# UNITED STATES PATENT AND TRADEMARK OFFICE

# Office Action Summary

10/050,978

BECK, ROBERT C.

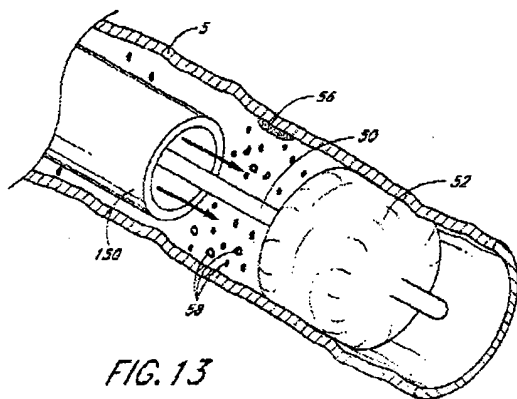
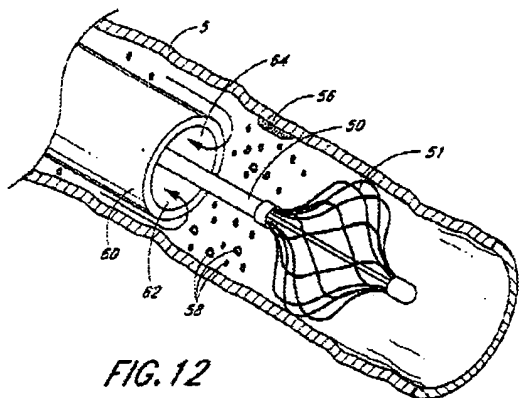
**Claims 1, 11, 12, and 13** are rejected under 35 U.S.C. 102(b) as being anticipated by Muni, et al., U.S. Patent Number 6,454,741.

The cited patent teaches and shows in figures 12 and 13, the steps of inserting and positioning an occlusion device in a vessel without placing an occlusion device proximal of the lesion in the same vessel, treating the lesion, positioning an extraction section at a location near the lesion, supplying a fluid to the extraction section, and providing a sheath having an extraction lumen proximal of the extraction section.

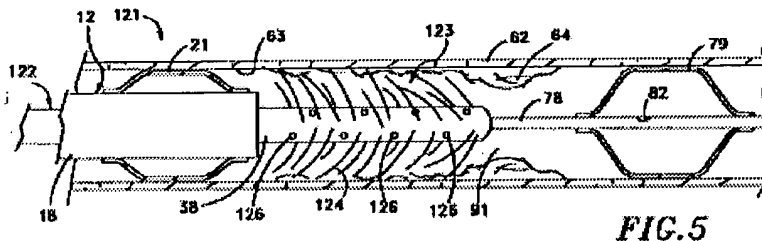
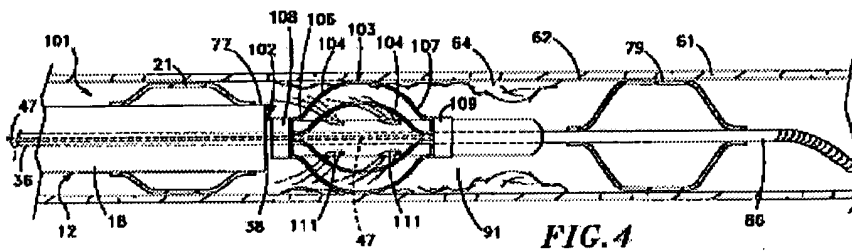
As referenced above, Muni shows in figures 12 and 13, the steps of inserting and positioning a single balloon occlusion device in a vessel without placing an occlusion device proximal of the lesion in the same vessel, treating the lesion, positioning an extraction section at a location near the lesion, supplying a fluid to the extraction section, and providing a sheath having an extraction lumen proximal of the extraction section. Imran teaches the use of triple balloon devices to treat affected areas in vessels.

Figures 4 and 5 of the Imran Patent show various embodiments use for the treatment of stenosis in vessels. Please note that figure 4 shows an embodiment with three balloons and figure 5 shows an embodiment with two balloons and bristles (124).
